DEVELOPMENT REVIEW BOARD MEETING

3. **Resolution No. 421. 6753 SW Montgomery Way SRIR and SROZ.** The applicant is requesting approval of an Abbreviated Significant Resource Impact Report (SRIR) and Significant Resource Overlay Zone (SROZ) large lot exception for construction of a residence at 6753 SW Montgomery Way.

**DEVELOPMENT REVIEW BOARD
RESOLUTION NO. 421**

Exhibit A1
Staff Report
Wilsonville Planning Division
6753 SW Montgomery Way SRIR SROZ

Figure 1. Tree Locations (all trees 6-inches DBH and over – see Table 1 for location info)

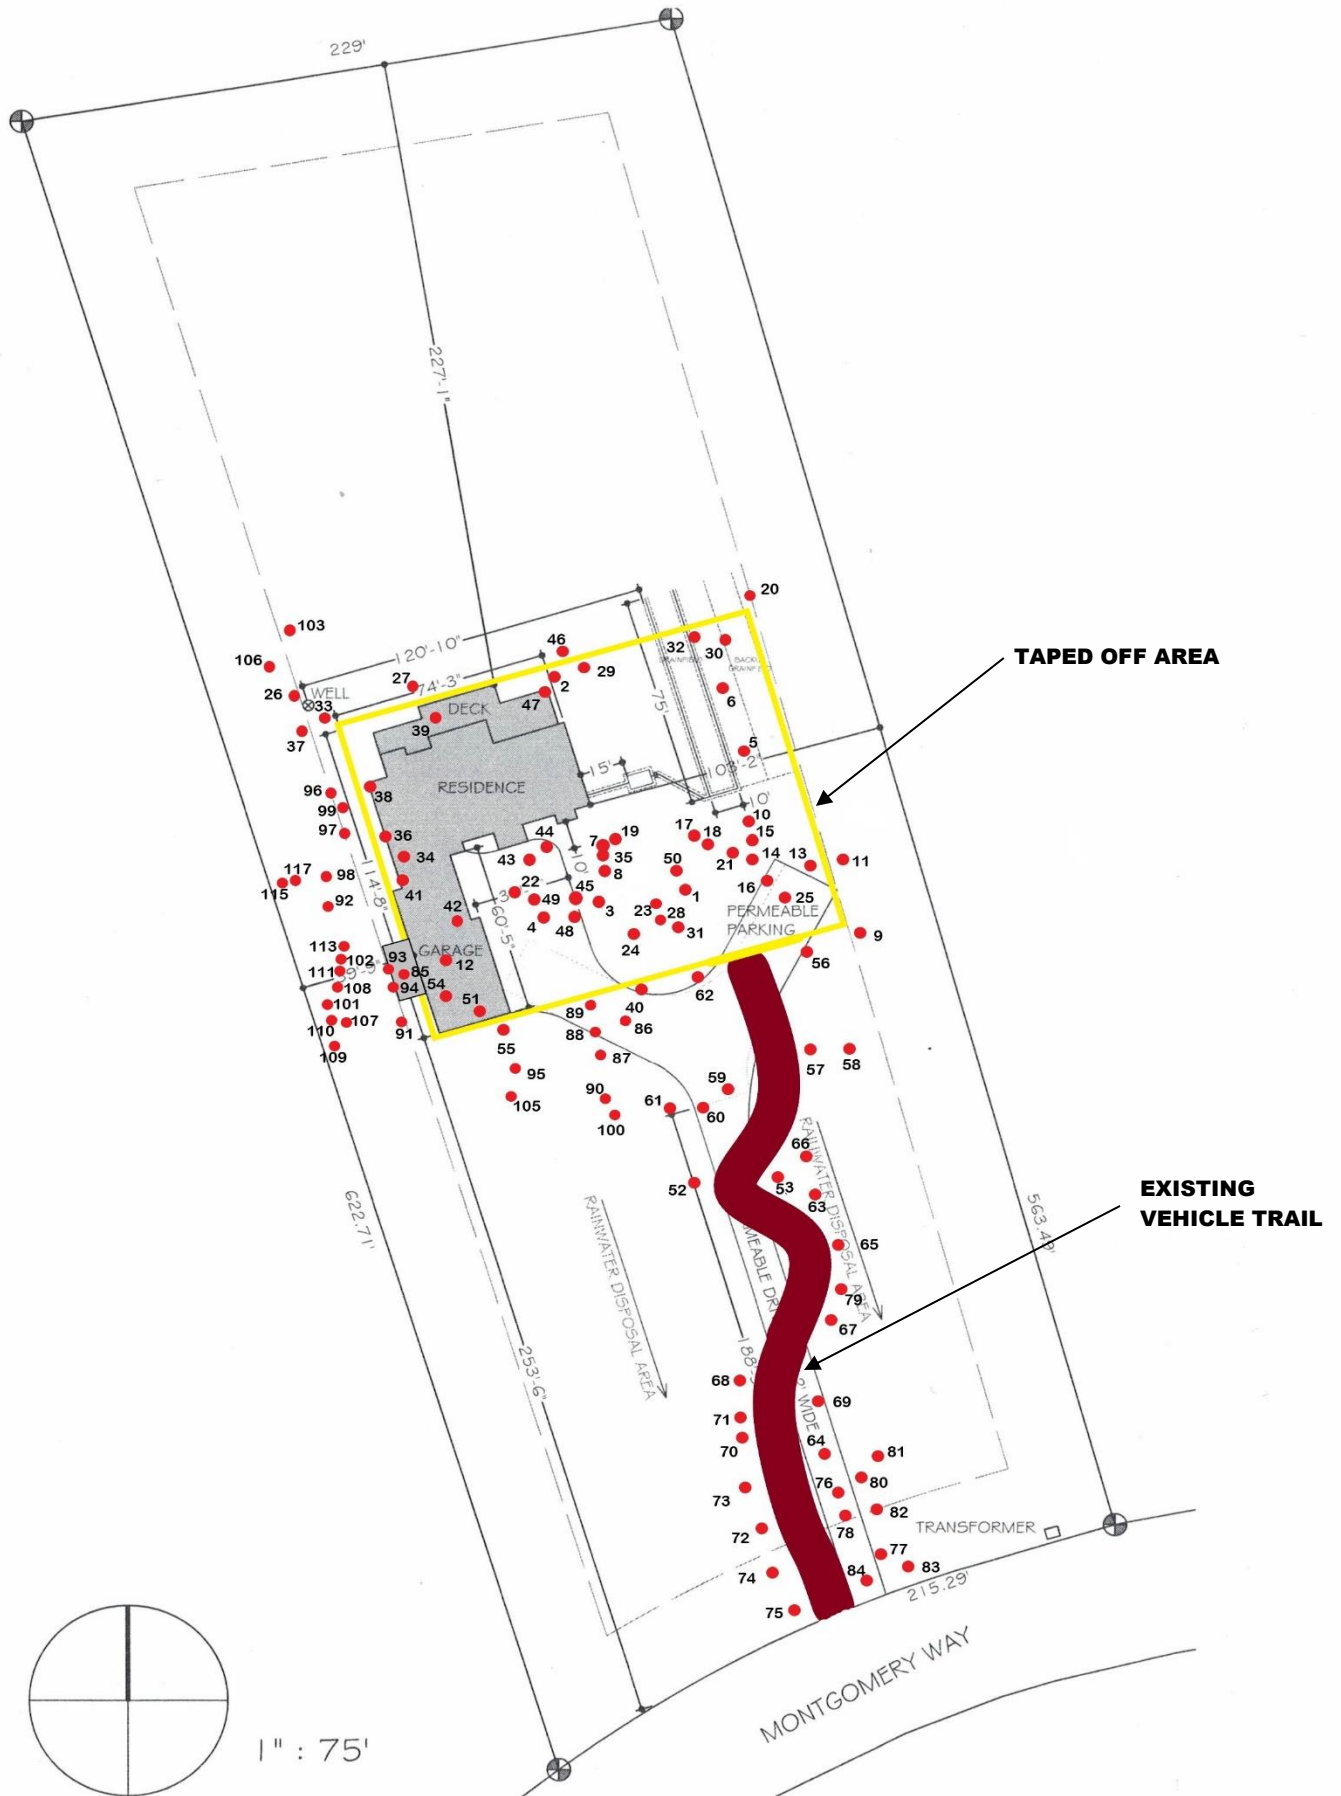
3. Identification of trees proposed for preservation, as listed in Arborist Report, on Figure 1, Tree Locations. Provide findings demonstrating how removal of native vegetation within City of Wilsonville Page 2 the SROZ is minimized and design alternatives were considered to prioritize and preserve significant large mature trees, such as Tree #4 (45-inch Western red cedar) and Tree #47 (38-inch Western Red Cedar).

The soils were studied at multiple locations on the property by licensed professionals. The proposed location for the septic system is the only area that meets the criteria set forth by Clackamas County (See attached septic approval report provided by Clackamas County). The location of the residence was determined to be soil with the best drainage and lowest water table. Other contributing factors for the siting of the residence include CC&R's for the site that require living spaces to be located above the 90 foot contour (See Site Plan for the location of the 90 foot contour). OAR 690-210-0030 Placement of Water Supply Wells was reviewed for well placement, which aligns with current well placements of adjacent properties. Ingress and egress maintenance requirements for future maintenance were also considered. A licensed arborist was retained to determine a tree mitigation and replanting plan that both preserves existing trees to the greatest extent possible and provides a plan for replanting of primary, midstory and understory for future restoration (See Tree Mitigation Plan). Tree #4 is located in the middle of the proposed driveway and too close to the garage to preserve. Tree #47 is located at the northeast corner of the proposed residence and is too close to the residence to preserve. The two trees in question were marked for removal as shown on the arborist's report.
